PL-2303HX Edition USB-to-Serial Bridge Controller
Migration Guide Application Note

PL-2303HXD Hardware Design Migration

Figure-1: PL-2303HXD Schematic Diagram Reference

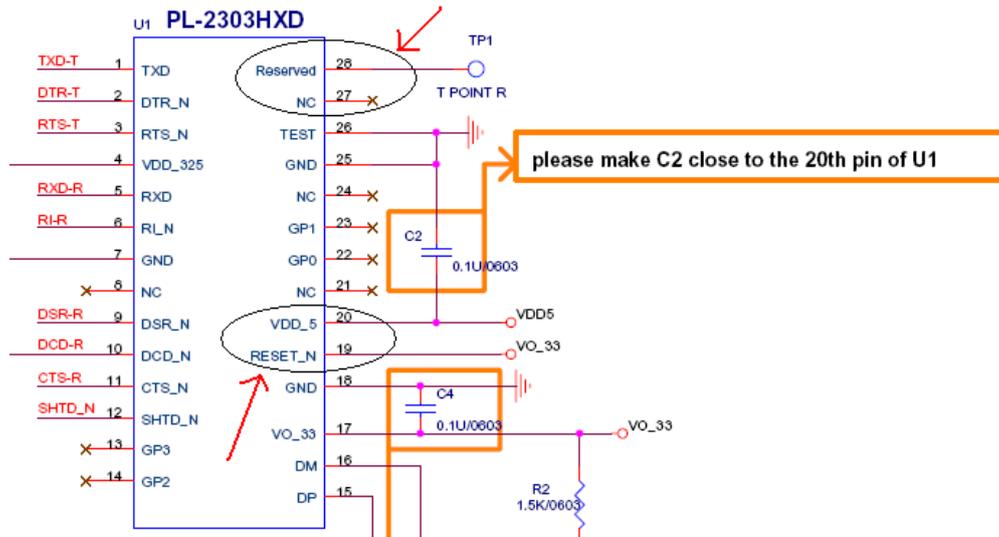
> If the PCB layout was designed with Pin 19 as NC, you can short Pin 19 (RESET_N) to Pin 20 (VDD_5). Pin 19 is 5V tolerant. Otherwise, the PCB needs to be re-layout. See Figure-1 below.

> PL-2303HXD already has an integrated clock generator so pin 27 is NC while pin 28 should be floating.

Figure-2: PL-2303H and PL-2303HXD Schematic Diagram (5V Capacitor) Comparison

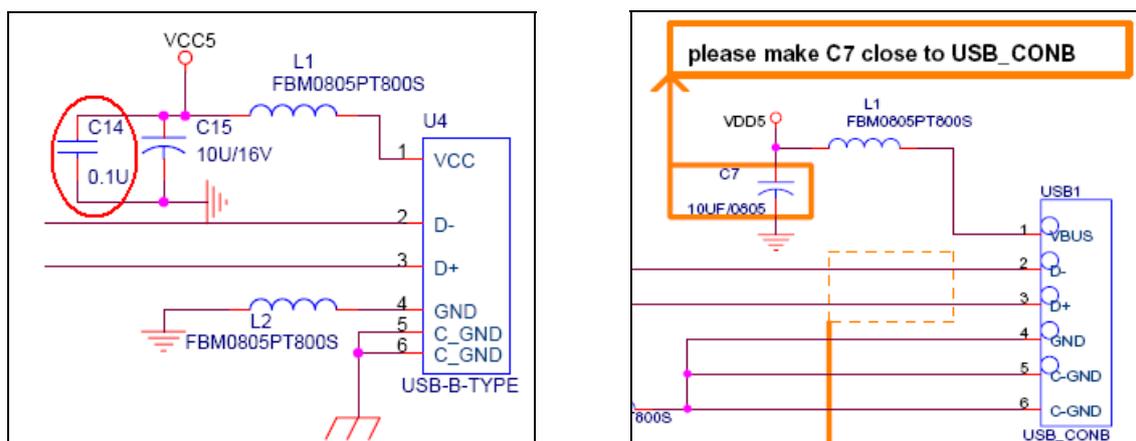
> For PL-2303HXD, you can remove the 0.1μF capacitor (C14 in PL-2303H schematic) and just use 10uF as 5V capacitor (C7 in PL-2303HXD schematic). See Figure-2 below.
